Memo

To:	By & Havn
At.:	Michael Lundgaard, By & Havn
From:	Bo Brahtz Christensen, DHI
Project	11823523 Lynetteholm
Date:	12 May 2021
Subject:	Additional comments on the Esbo consultation responses

Figure 1   Drogden before (1985) and the Öresund Link (2020).

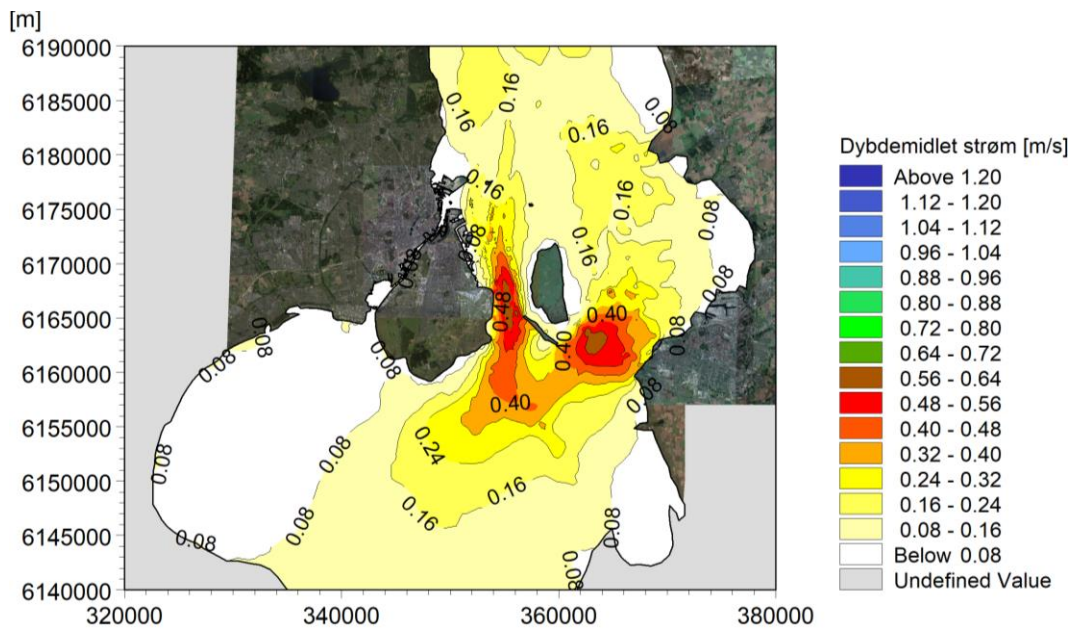
In connection with the Øresund Bridge project and the tunnel and bridge, a new island, Peberholm, was established and likewise reclamation of a larger area east of Copenhagen Airport, where the tunnel portal is established (see Figure 1). The filling resulted in a narrowing of the Drogden trench in an area where some of the highest current speeds occur, cf. Figure 2 and Figure 3. The flow resistance is proportional to the square of the currrent speed. The filling at the airport is located in an area where the narrowed cross-section significantly impacts flow resistance. The Lynetteholm filling is placed in an area where the current conditions are much more moderate and less critical for the flow

resistance through Øresund. As part of the bridge project, compensation excavation was carried out to mitigate the blocking effect of the project. The most challenging part of the calculations was calculating how compensation pits should be excavated, bridge piers designed and placed, and the design and location of the island of Peberholm. A very complex calculation matrix. Compensation excavation does not make sense in the case of Lynetteholm since to minimise the volumes of excavated material, an area with high current speeds resulting in a high dispersion of excavated sediment spill will have to be selected. As shown in Figure 2 and Figure 3, such an area is far away from the Lynetteholm project's primary impact area, introducing a new and more significant and not least undesirable environmental impact.

Figure 4   Modelled time series of the depth-centred concentration (mg/l) in the sediment plume northeast of the disposal sites.

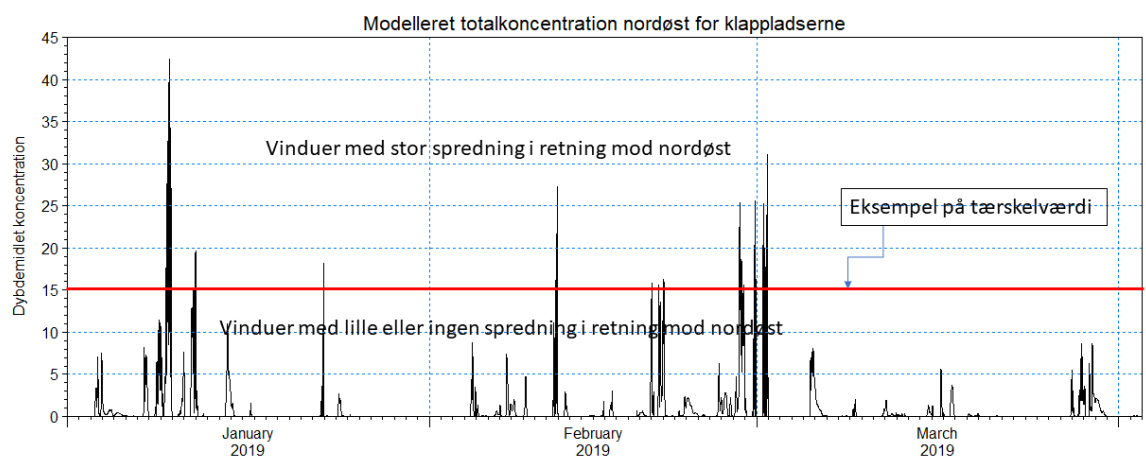
The model calculations show that there will be a time slot where the spreading of the disposed sediment is large. Therefore, it will be possible to reduce the dispersion of the dredged material if sediment disposal is not taking place when it gives rise to an extensive or undesirable spreading to, for example, the Natura 2000 area at Falsterbo. A large spreading towards the northeast, as shown in Figure 4, is primarily related to isolated incidents of up to one day. For example, if a threshold is used as indicated by the red line, there will be a few days when no sediment disposal can take place and a few days when it is just some hours.

To ensure optimal sediment disposal and a reduced spreading, it is proposed to establish a Turbidity Management Group (TMG) with stakeholder representatives, who can continuously follow the sediment disposal and its impact. To assess the impact, it is proposed to establish four stations with turbidity meters. One station is placed west of the disposal sites and is intended to measure the natural background concentration. The second station is located just inside the Natura 2000 area at Falsterbo, east of the sediment
